Tarrawonga Coal Mine LoM Mod. 7 Groundwater Assessment Peer Review

Prepared for:

NSW Department of Planning
Industry and Environment

10 December 2020

Figure 2 - minor Vickery borefield drawdown (after HydroSimulations 2018, Figure 62)

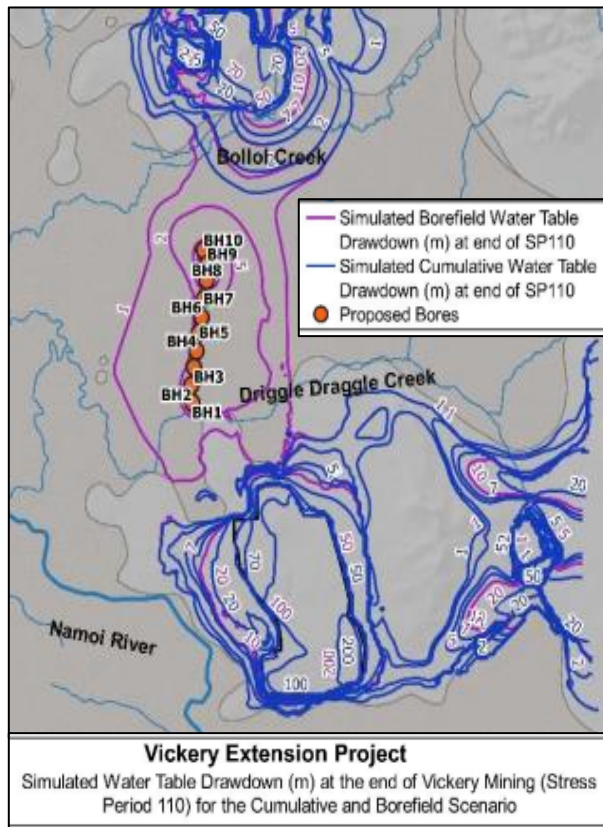
It is noted that the Vickery Extension assessment (HydroSimulations 2018), included in its modelling the proposed Vickery water supply borefield that is sited between Tarrawonga and Vickery. The Vickery Extension modelling predicted that the cumulative drawdown extents between these projects would coalesce to a very minor degree (order of one metre near Bollol Creek - see Figure 2), and even then, only due to the assumed (conservatively high) Vickery borefield extraction, which may not be realistic for current borefield plans.

In summary, although the Tarrawonga cumulative impacts assessment did not specifically include extractions for the Vickery Extension mine and water supply borefield, it is reasonable to infer that including those effects would not materially change the Tarrawonga predictions of BTM complex cumulative impacts.

Figure 3 - mapped extent of alluvium and pit crest (after People for the Plains, 2020)

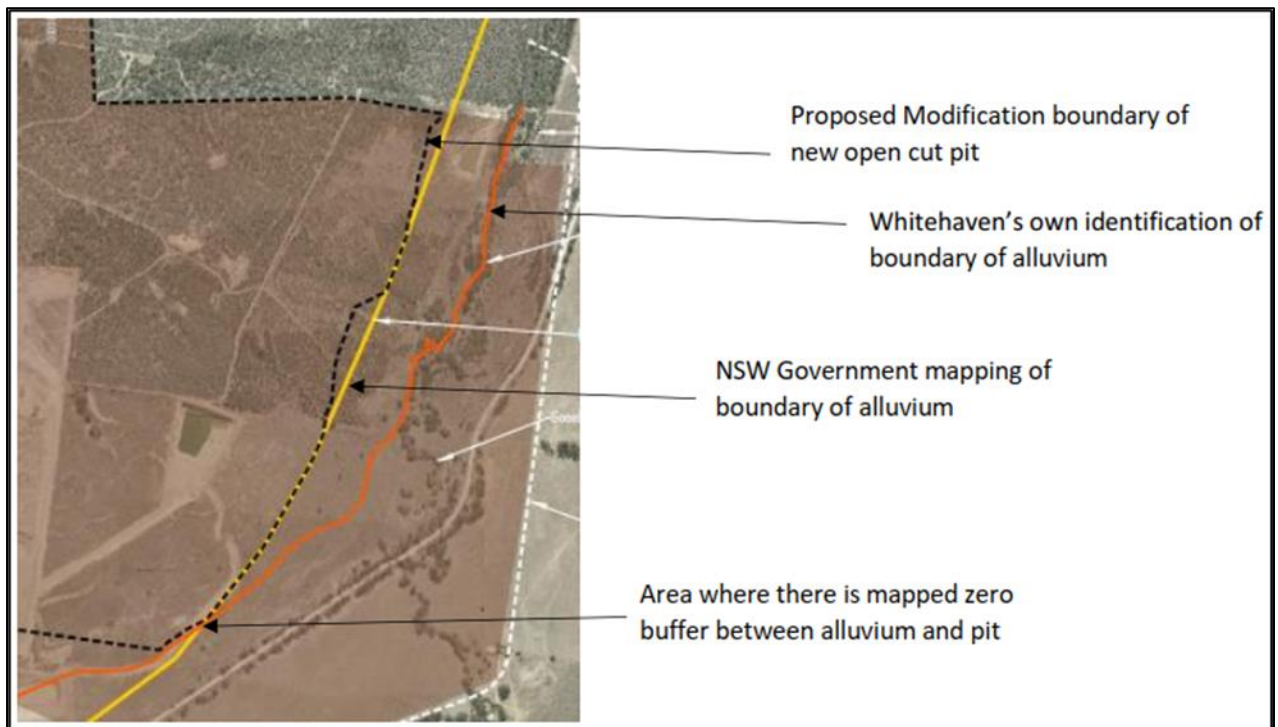
These statements appear to be in conflict with some key figures in the Modifications report that show the pit extent at its south-eastern corner. For example, Figure 3 below is based on Figure 5-2 of the Modification report, but is actually taken from page 5 of the submission by the People for the Plains. It shows that the pit crest extends up to the alignment of the NSW Government mapped alluvium (yellow line) along most of the eastern boundary. At its south-east corner, however, the pit crest aligns with the orange line that represents the alluvium mapped by SLR based on soil surveys and a topographical and geomorphological assessment (Attachment J of HydroSimulations 2019). In any case, it appears that the pit crest will extend up to the western-most alignment of the mapped alluvium, but would not actually ‘intercept’ the alluvium.

The problem is that the location of the pit crest is uncertain, based on the information presented. For example, Figure 3 below shows the south-east corner of the pit at about 150 metres from Goonbri Road. However, Figure 2-2 of the Modification report, shown below as Figure 4, shows this point at about 120 metres from Goonbri Road, and perhaps 80 metres from the nominal flood bund alignment (subject to detailed design). These

distances have been scaled from the figures and are therefore approximate. It is not known whether the flood bund will be mostly aligned with the alluvium mapped SLR (2019), but indications are that may be the case along most of its alignment.

Figure 4 - pit crest general arrangement (Modification report, Figure 2-2)

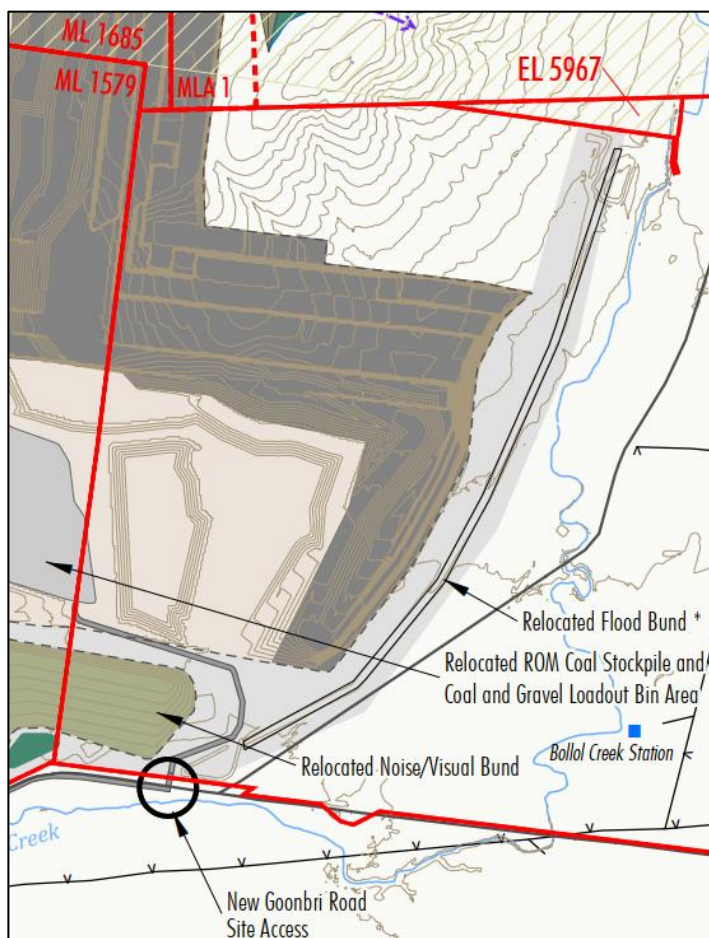
- Firstly, based on statements in the Modifications report, it is assumed that the pit crest is aligned with the western-most mapped alluvium, and the flood bund will actually be located between the pit crest and Goonbri Road, as shown generally in Figure 4. The soil mapping shows that the alluvium is dry at its mapped extent (SLR 2019), so there is no flow path from saturated alluvium towards the pit or final void under normal conditions. This means that the source of leakage would have to be from any floodwater that might pond against the flood bund, which is some 100-200 metres from the pit crest generally, except near the south-east corner of the crest where it may be around 80 metres.

Figure 5 - alluvium and basement conceptual models (after HydroSimulations 2019, fig.16)

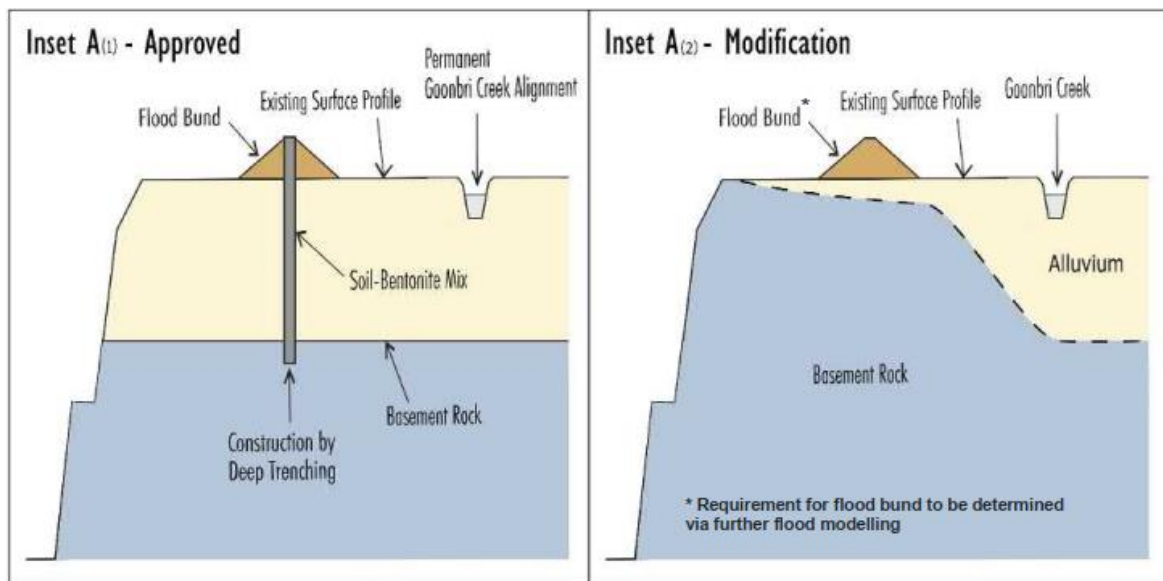
With reference to Figure 5, it is important to define the exact location of the pit crest and the flood bund and the mapped alluvium in order to assess whether or not there may be the potential for leakage towards the pit and/or post-mining void via the alluvium and/or fractured rock basement due to flood inundation events, as several submissions have commented (eg. DPIE Water and People for the Plains).

As the mapped alluvium is effectively unsaturated in this location, the pathway for leakage under the Mod 7 arrangement would be mainly via the fractured rock ‘basement’ of the Maules Creek Formation (Figure 5). This has arguably not been ignored in the Mod 7 reports, in that Hydrosimulations (2019) suggest on page 42 that the properties of the in situ ‘basement’ results in similar drawdown predictions under Mod 7 as for the approved case with a low permeability barrier under the flood bund (Figure 5).

While this review considers that to be a perfunctory rather than comprehensive assessment, the leakage potential is probably low, based on the following reasoning:

Figure 6 - Predicted 1% AEP and PMF flood extent (after HEC 2019, figs 29 & 30)

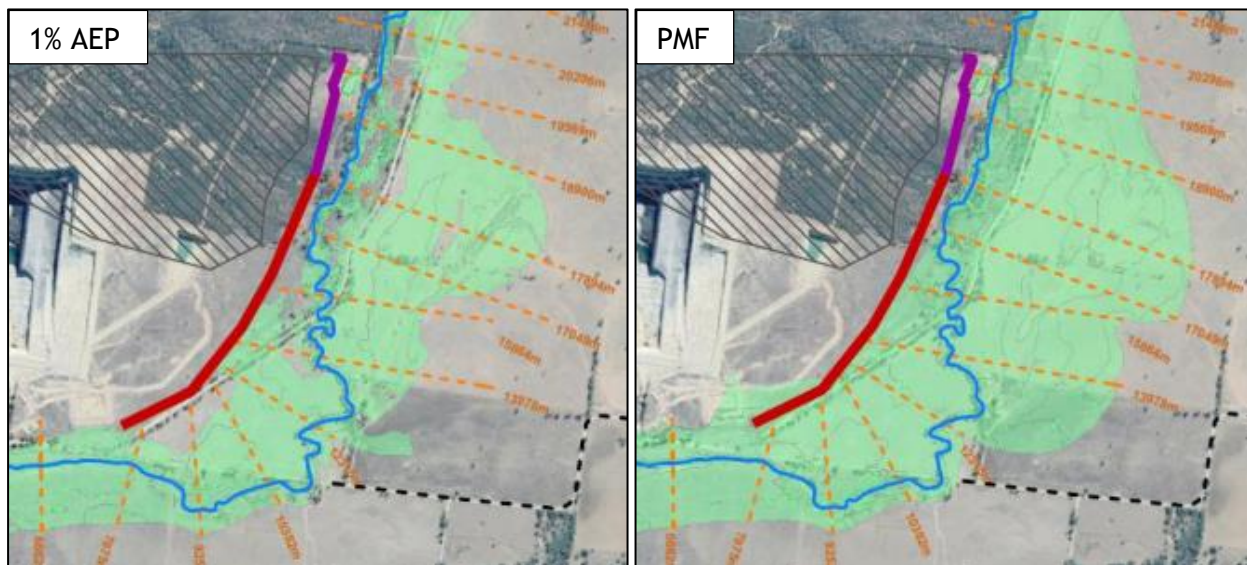
- Under those conditions, the 2D flood modelling prediction for the 1% annual exceedance probability (AEP) (‘1 in 100 year’ flood event), shows some ponding against the flood bund (Figure 6, after HEC 2019, Figure 29). The flooding assessment indicates that the ground level adjacent to the final void is at least 6 metres higher than the predicted flood level, which itself is lower than the flood bund crest by about 1 metre (HEC 2019, Table 33). Although the flooding assessment does not indicate the duration of such ponding, it does indicate that the 1% AEP critical storm duration is 2-3 hours, which implies that the flooding

duration would likely be in the order of days. This indicates little opportunity or potential for leakage from a 1% AEP flood event to adequately saturate the subsurface units and convey substantial volumes towards the pit or void. It is also noted that the probability of occurrence of a 1% AEP flood within the 10 year LoM period to 2030 is low at about 9.5%, while within a 100 year period it is about 63%, rising to about 85% within 200 years and 95% in a 300 year period (ie. it is likely during the closure period).

- Similarly, while the 2D flood modelling prediction of the larger event of the probable maximum flood (PMF; there is no established method of estimating its probability) shows some inundation on the western side of the indicative flood bund at its southern end (Figure 6), roadworks and pit crest bunding should apply adequate controls operationally to retain the floodwaters, and similarly for the post-mining landform.

The DPIE facilitated a discussion of this issue on 2 December 2020 with the peer reviewer, Whitehaven Coal and their consultants. It was confirmed that the groundwater modelling assumptions of the pit excavation alignments were appropriate. A brief report was subsequently provided to document additional information to address the issues raised (Whitehaven 2020). That report confirmed the assumptions above about the alignments of the pit crest, mapped alluvium, and nominal flood bund (subject to further modelling). The additional information also estimated that the potential leakage volume is low (generally less than 20 ML), and that adequate air space is available in the final void above the final lake level (9000 ML).

In summary, there is a low probability of flood occurrence within the LoM period, the flood bunding and other earthworks will be designed to constrain floodwaters adequate distances from the operational or final voids, and any sub-surface leakage volumes would be low and could be accommodated during pit operations or by the final void.
